**SUBJECT: LaSalle County Nuclear Power Station Units 1 and 2 Application for
Amendment to Facility Operating Licenses NPF-11 and NPF-18,
Appendix A, Technical Specifications
NRC Docket Nos. 50-373 and 50-374**

ATTACHMENT A
DESCRIPTION OF SAFETY ANALYSIS OF THE PROPOSED CHANGES

**ATTACHMENT B
PROPOSED AMENDMENTS TO THE
LICENSE/TECHNICAL SPECIFICATIONS**

FIGURE 1
TYPICAL WATER LEG SYSTEM

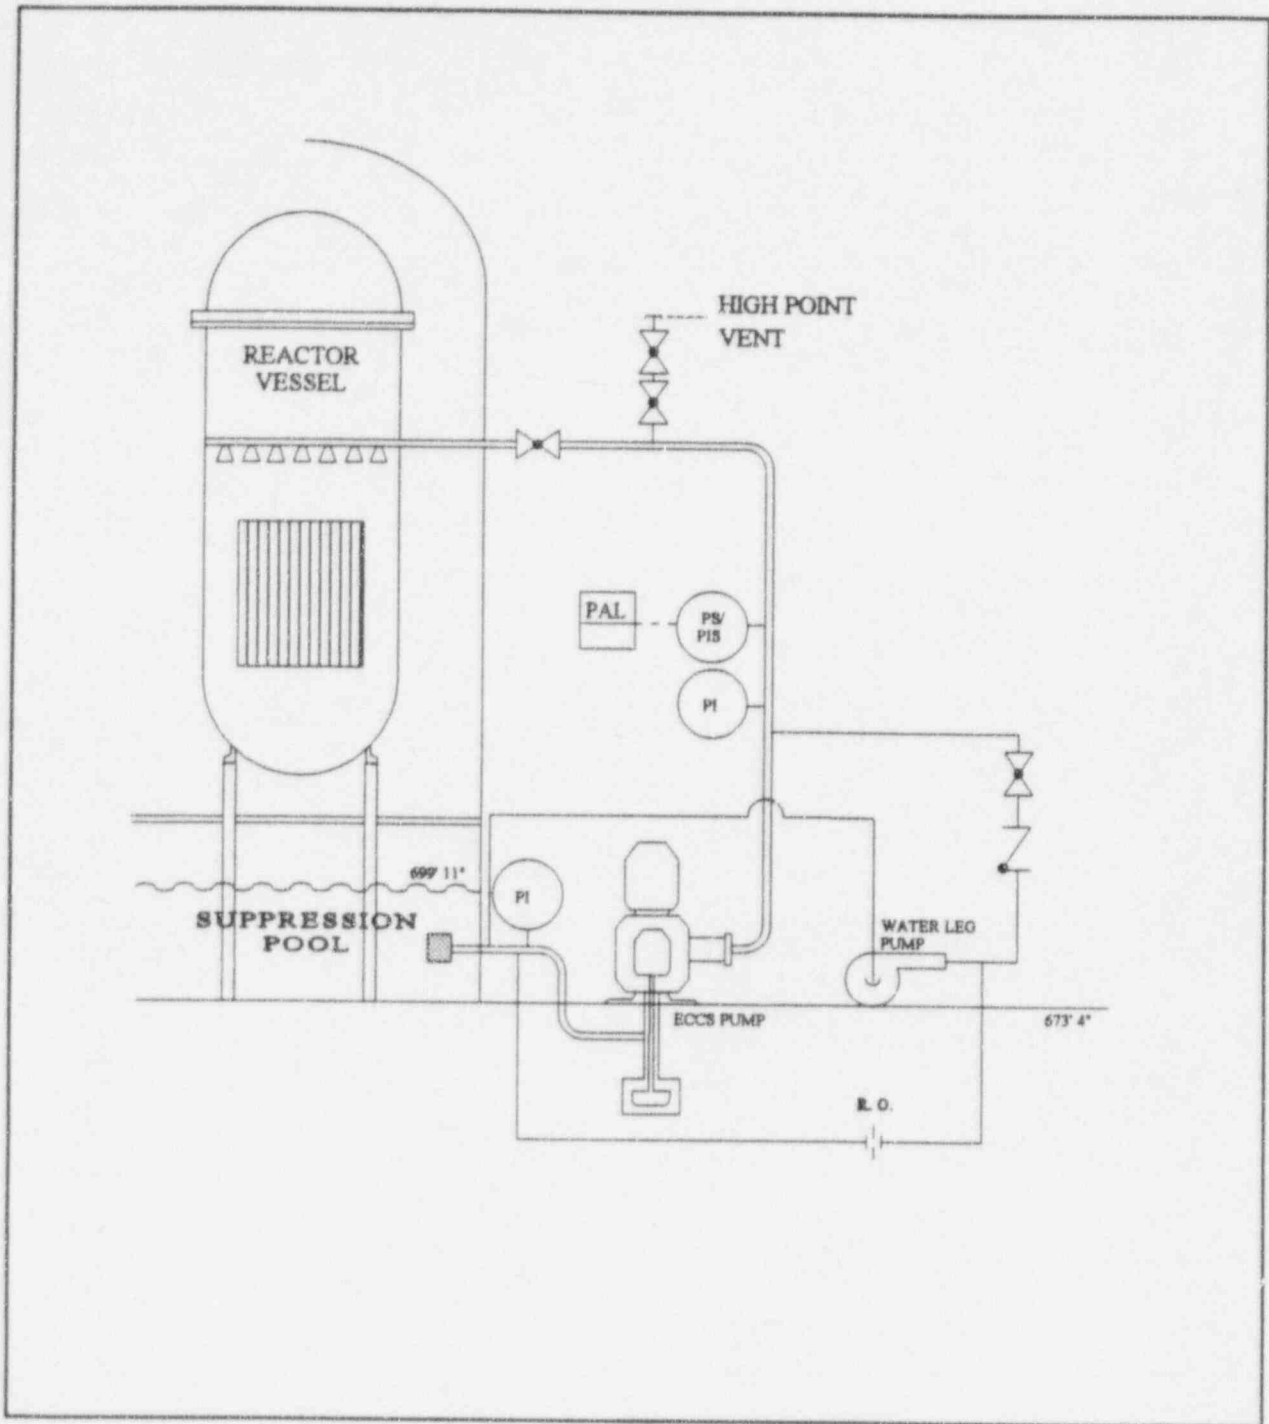
To ensure the lines are kept full, a water leg pump is provided for each ECCS division and for the RCIC system (refer to figure 1 for a simplified diagram of a typical water leg system setup). Indication is provided in the main control room as to whether these water leg pumps are operating, and a pressure switch on discharge lines of the ECCS and RCIC pumps provides an alarm in the Control Room on low discharge line pressure. This pressure instrumentation on the discharge line that performs this function is referred to as the "keep filled" pressure channel.

The proposed technical specification amendment decreases the setpoint allowable values for the ECCS and RCIC discharge line "keep filled" alarms. The proposed setpoint allowable values are based on the pressure head due to the height of water from the centerline of the pump discharge nozzles to the high point vents. The following table summarizes the proposed changes:

The proposed ECCS and RCIC discharge line "keep filled" alarm setpoint allowable values are based on the head of water between the centerline of the pump discharge nozzle and the associated system high point vent. The analytical limit, setpoint allowable value, and calibration setpoint for each instrument channel were calculated in accordance with Engineering and Construction Procedures TID-E/I&C-10, "Procedure for Analysis of Instrument Channel Setpoint Error and Instrument Loop Accuracy," and TAD-E/I&C-20, "Basis for Analysis of Instrument Channel Setpoint Error and Instrument Loop Accuracy." These procedures are based on NRC Regulatory Guide 1.105, Revision 2, ANSI/ISA Standard S67.04-1988, and ISA Recommended Practice update with published version P67.04, Part II. Attachment E is CECo NED Nuclear Design Information Transmittal (NDIT) No. EIC-93-011-2, dated 6/3/94, summary report of the calculations that determine the ECCS system "Keep Filled" Alarm Ideal Setpoint and Technical Specification Allowable Values.
